Network PTZ Dome Camera Firmware

Version: V5.5.0

Release Note

2.3 Hik-Connect

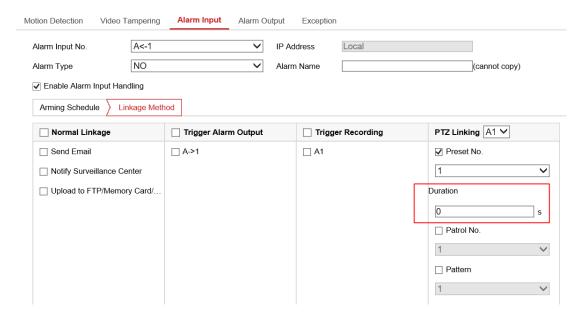
2) You can also open HIK-Connect by web interface or client, there will be a prompt information to let you create Verification code, and the verification code is visible. If the factory equipment already have the verification code, the device will reminder you to change it.

3) UPNP is disabled by default, if the device was registered to HIK-Connect, UPNP will be opened. UPNP will be close if the device was unbundled from HIK-Connect platform.

3.2 Rapid Focus supports 4 Scenes.

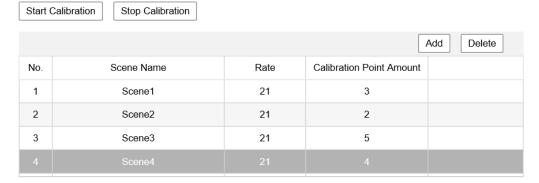
Rapid Focus supports 4 Scenes, the Rate and Calibration Point Amount are configurable. Only DF2307IX, DF3607IX and DF3609IX PTZ Cameras support Rapid Focus.

Finish calibration before you enable eagle vision focus. Disabling eagle vision focus before you delete all scenes.

3.3 Security Question

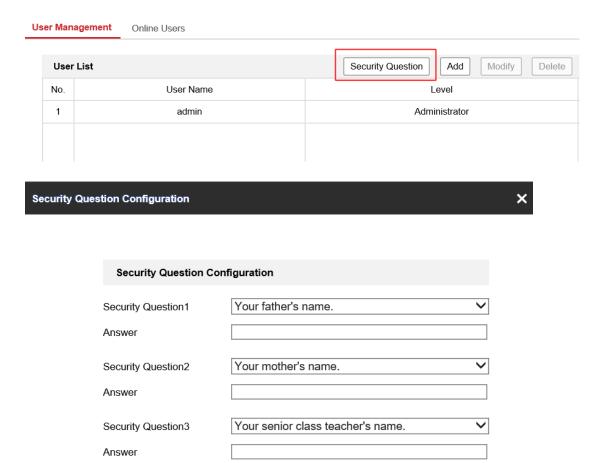
- 1) Support Security question in order to help customers get back passwords that might have forgotten.
- 2) In order to ensure safety, reset password operation must be in local area network.
- 3) User can create 3 common questions, there has 10 optional questions.
